MECKLENBURG COUNTY
DEPARTMENT OF ENVIRONMENTAL HEALTH

APPLICATION FOR SOIL INVESTIGATION

SOIL INVESTIGATION REPORT

SITE INVESTIGATION REPORT
INDIVIDUAL SEPTIC TANK SYSTEM
WITH SUBSURFACE,
SOIL ABSORPTION,
EFFLUENT DISCHARGE

DIAGRAM OF PROPERTY

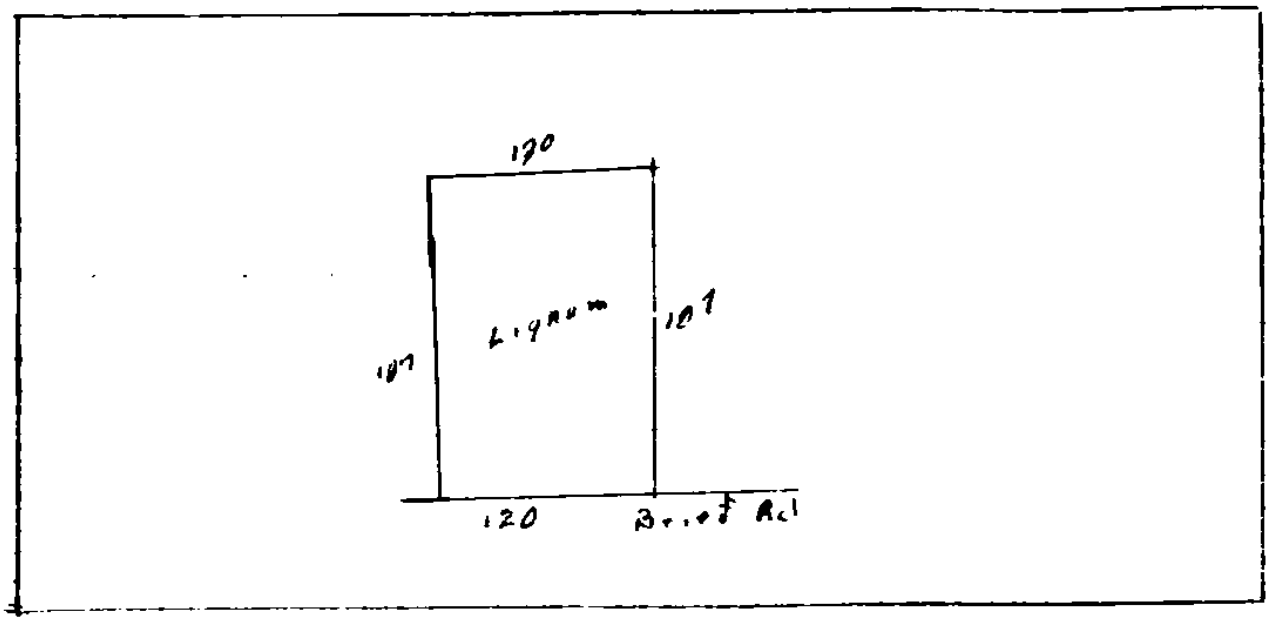
Soil Properties	Soil 1	Soil 2	Soil 3	Soil 4
1. Soil Series	Lyman			
2. Soil Slope	Suitable 2-6%			
3. Soil Depth	unsuitable < 36"			
4. Soil Texture	unsuitable 2:1 [illegible] clay			
5. Soil Structure	unsuitable [illegible] platy			
6. Restrictive Horizons				
7. Soil Drainage	Suitable water table 72"			
8. Soil Permeability (Percolation Rate)	unsuitable V. Slow >200 min/in			
9. Other				
10. Overall Rating	unsuitable

Recommendations Based on the investigation, the soils on the lot were found to be unsuitable for the installation of a septic tank system.

See diagram on back
